ORIGINATION FORM

Proposed Revisions to a Standard Plans Index

Index Number: 646-001

Index Title: Aluminum Post and Pedestal Mounted
Pedestrian Detectors and Signals

LAST REVISION 11/01/21	DESCRIPTION:		FY 2023-24 STANDARD PLANS	ALUMINUM POST AND PEDESTAL MOUNTED PEDESTRIAN DETECTORS AND SIGNALS	INDEX 646-001	SHEET 1 of 1
---------------------------	--------------	--	------------------------------	--	------------------	-----------------

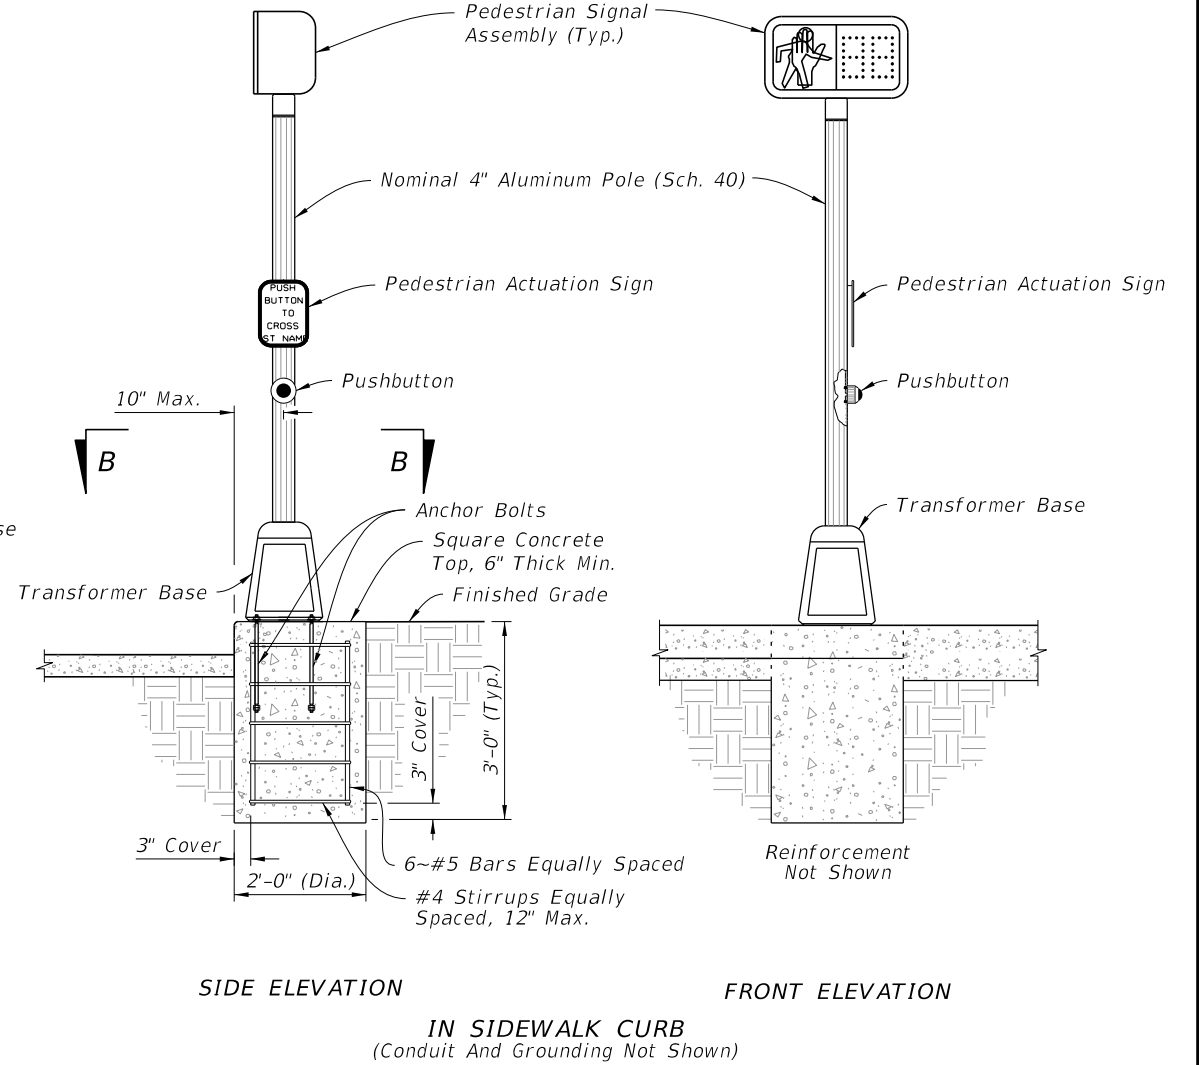
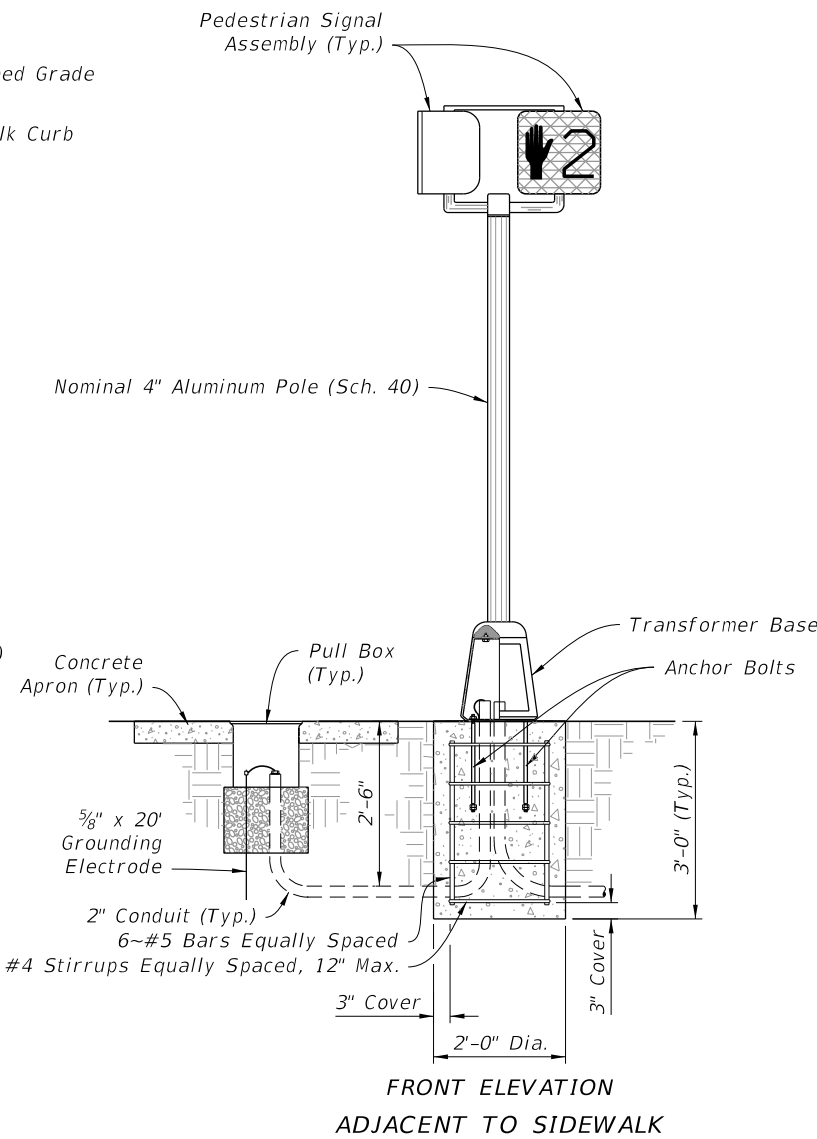
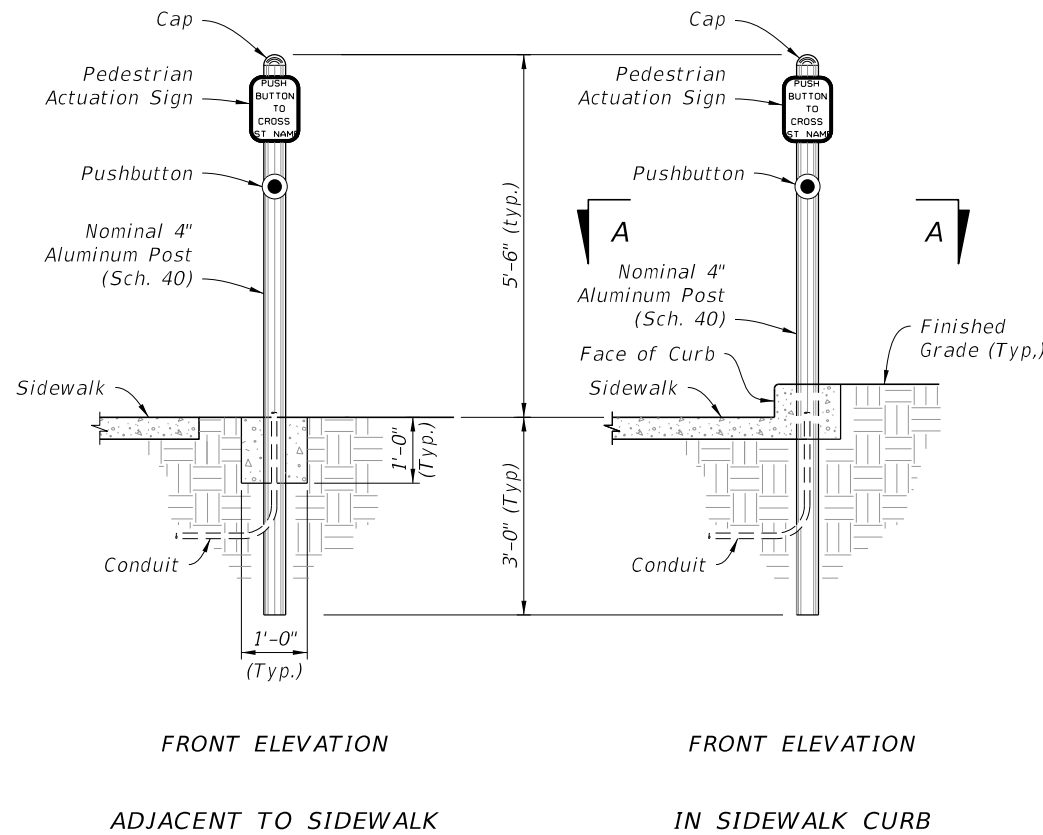
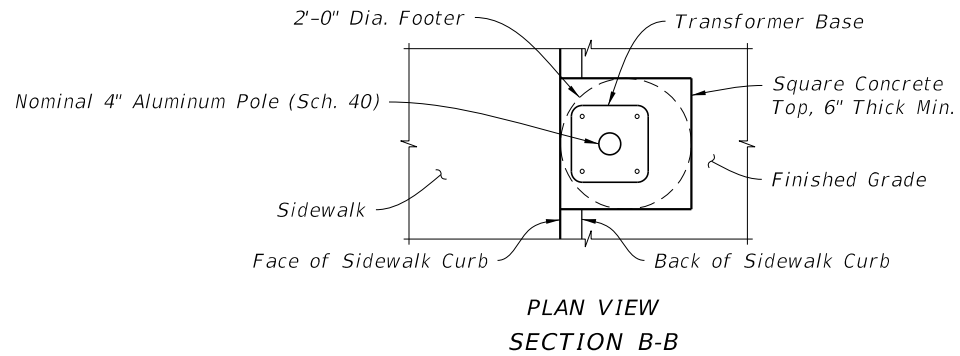
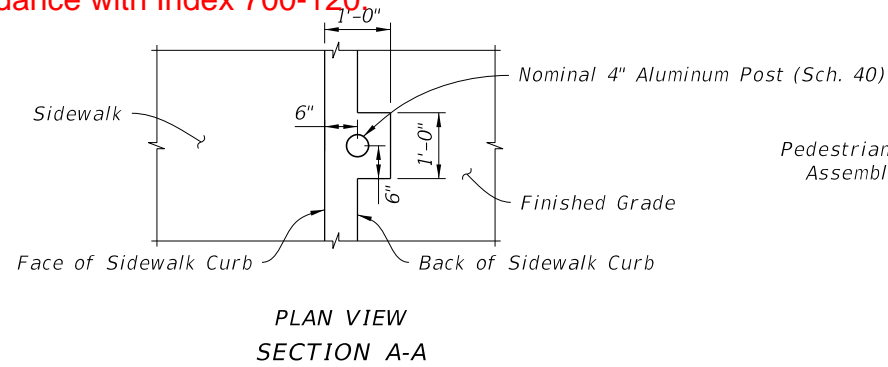
6. In lieu of footing design shown, a Spread Footing may be used in accordance with Index 700-120.

LAST REVISION 11/01/23	REVISION	DESCRIPTION:	 FY 2024-25 STANDARD PLANS	ALUMINUM POST AND PEDESTAL MOUNTED PEDESTRIAN DETECTORS AND SIGNALS	INDEX 646-001	SHEET 1 of 1
---------------------------	----------	--------------	---	--	------------------	-----------------

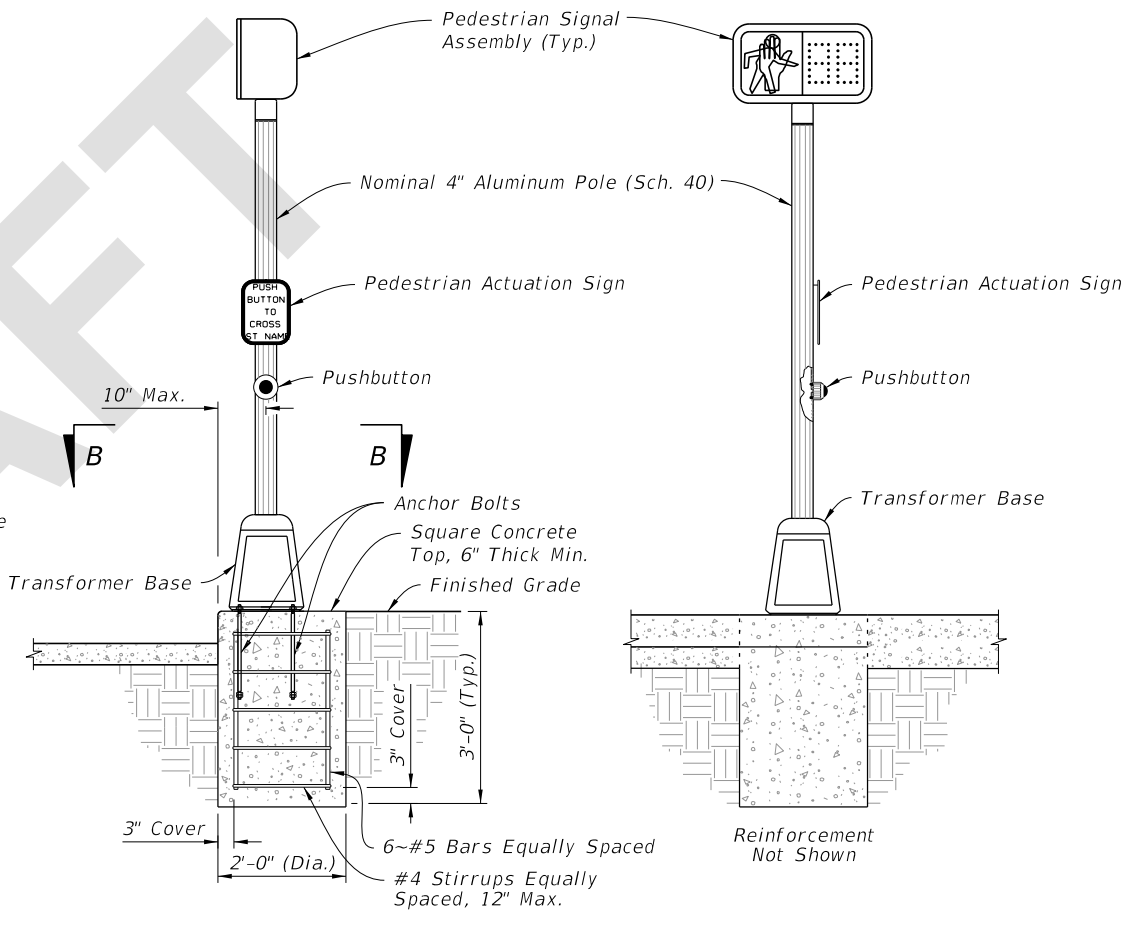
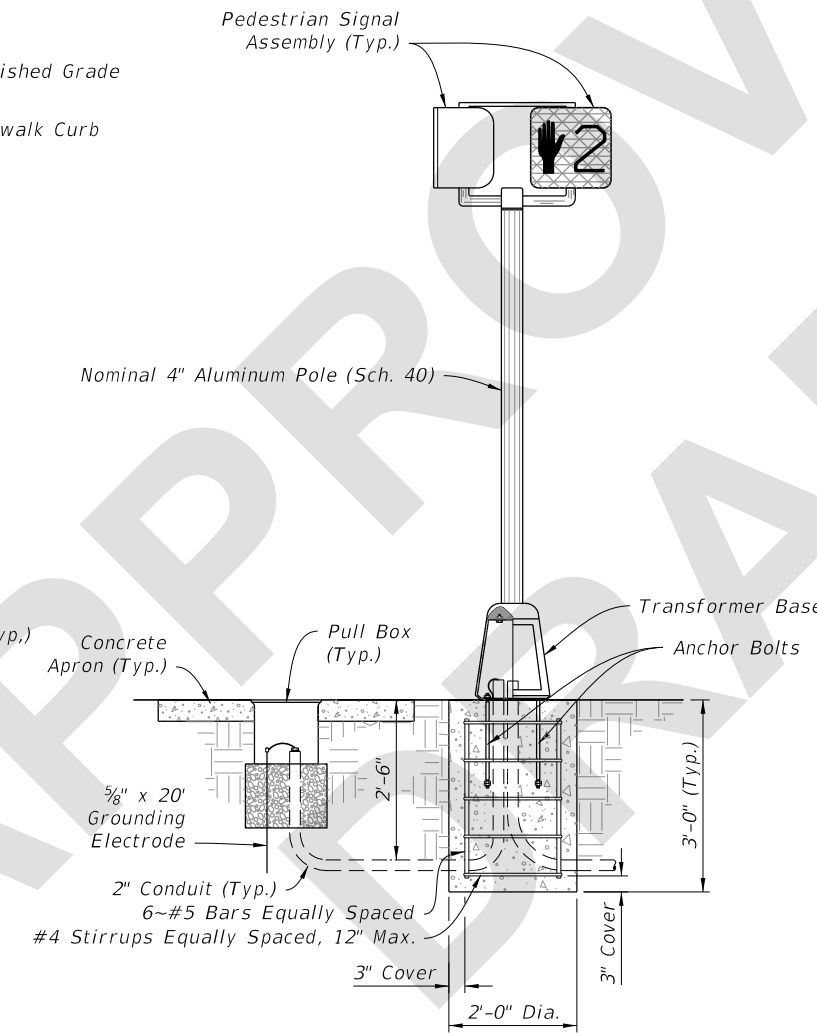
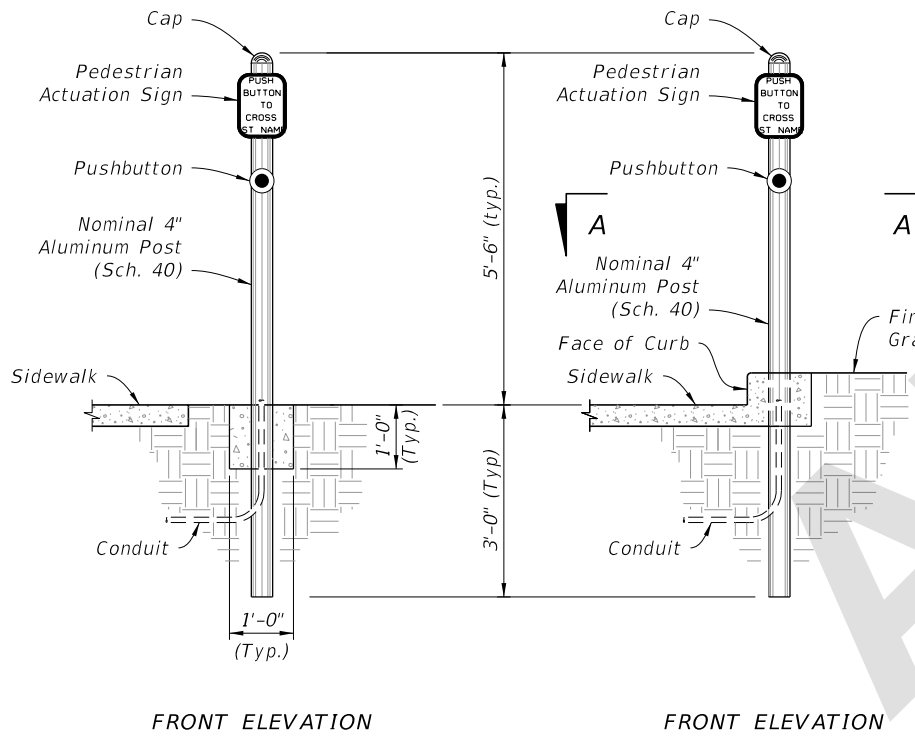
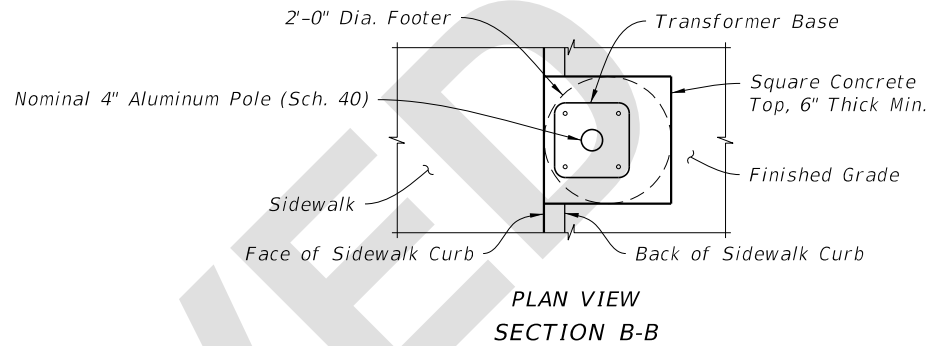
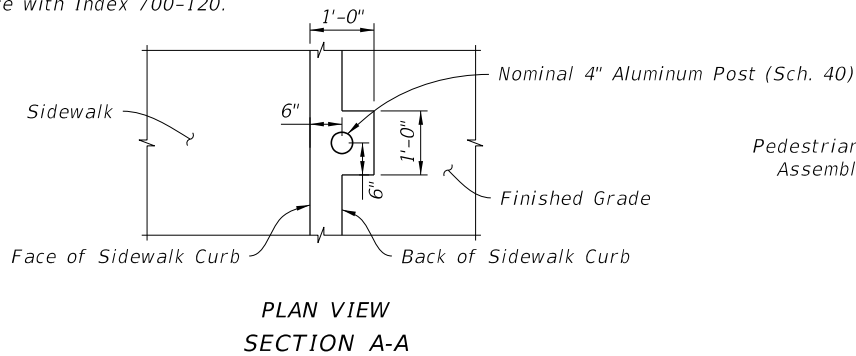
Added Note 6, "In lieu of footing design shown, a Spread Footing may be used in accordance with index 700-120."

Note 6 was added because of new spread footing design in Standard Plans Index 700-120.

1. Work this Index with Specification 646.
2. For Pedestrian Signals see Index 653-001.
3. For Pedestrian Detector Assembly (i.e., Pushbutton and Sign) details see Index 665-001.
4. Footing may be Cast-In-Place (C-I-P) or Precast.
5. As an alternative to the direct buried "Post Mounted" Pedestrian Detector Assembly shown below, the post may be installed on a transformer base. Use a transformer base included on the APL approved as an alternative to a "Post Mounted" assembly,
6. In lieu of footing design shown, a Spread Footing may be used in accordance with Index 700-120.
